RE: ZC 23-25, 100 Grist Mill Ensign Bickford Site Plan Amendment

DESIGN REVIEW MEMORANDUM

To: George K. McGregor, AICP, Director of Community Planning and Development
From: Adam D. Kessler, P.E., Deputy Town Engineer *AK*
Subject: **Engineering Comments – Proposed Parking Lot Expansion**
#100 Grist Mill Road

Existing Condition 100 Grist Mill

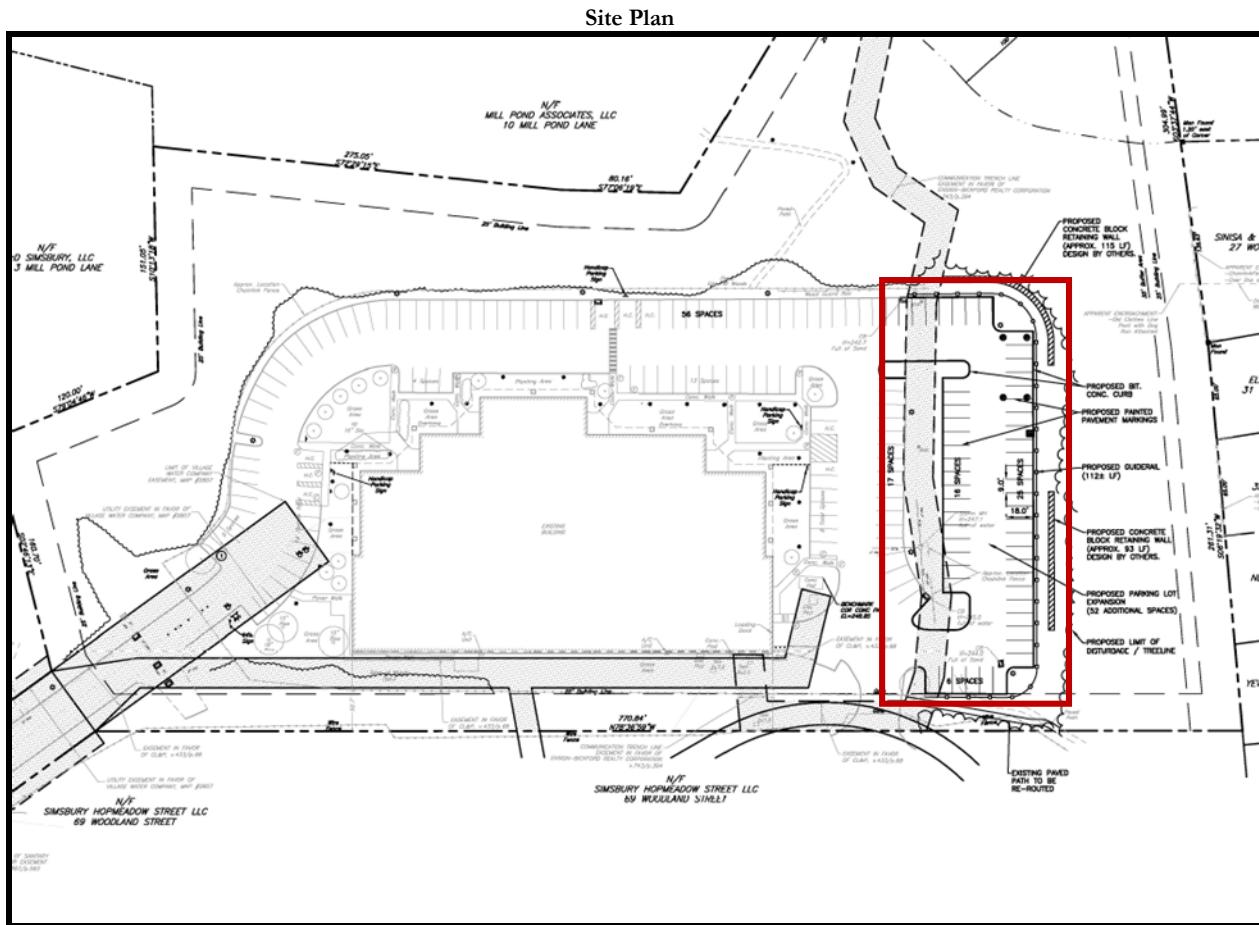
Ensign Bickford plans to add 52 additional spaces on the east side of the property adjacent to the existing parking lot, shown in the red highlight below. Limits of disturbance shows encroachment to adjacent residential property to be no closer than 110 feet.
